Intel[®] StrongARM^{*} SA-1110 Microprocessor

Specification Update

September 2000

Order Number: [278259-018](#)

Figure 11-3. Palette Buffer Format

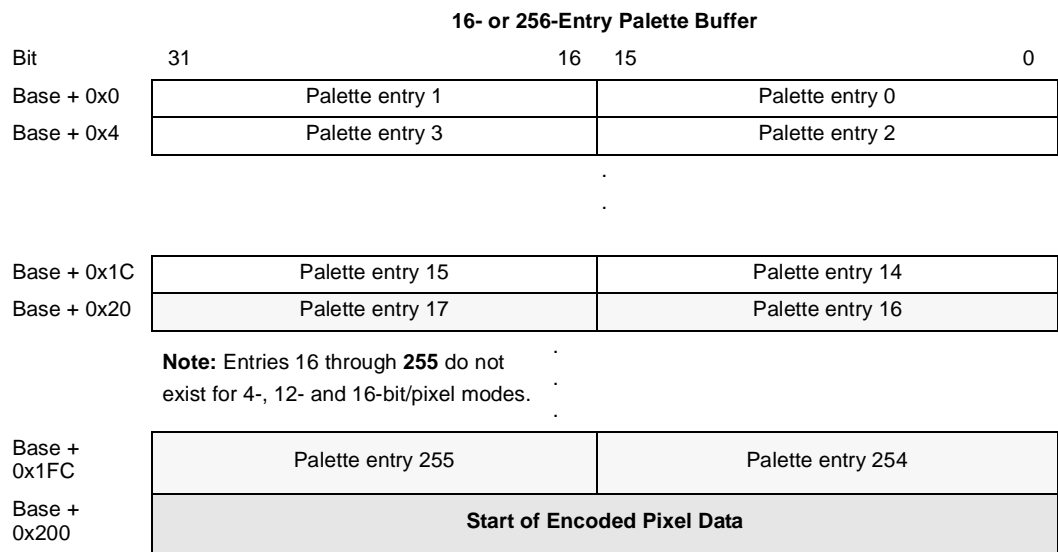
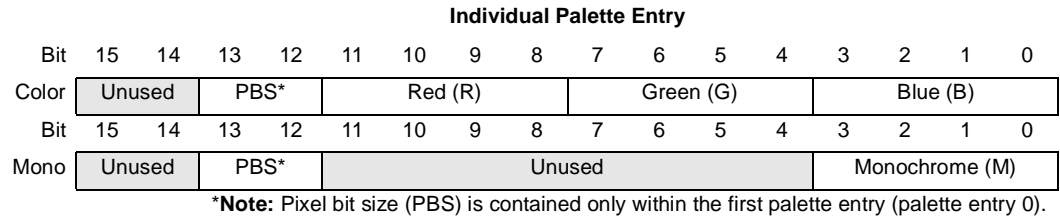
20. Frame Buffer: Section 11.7.1.2

Changed 254 to 255 in Figure 11-3. The figure now appears as follows:

Note: Entries 16 through 255 do not exist for 4-, 12- and 16-bit/pixel modes.
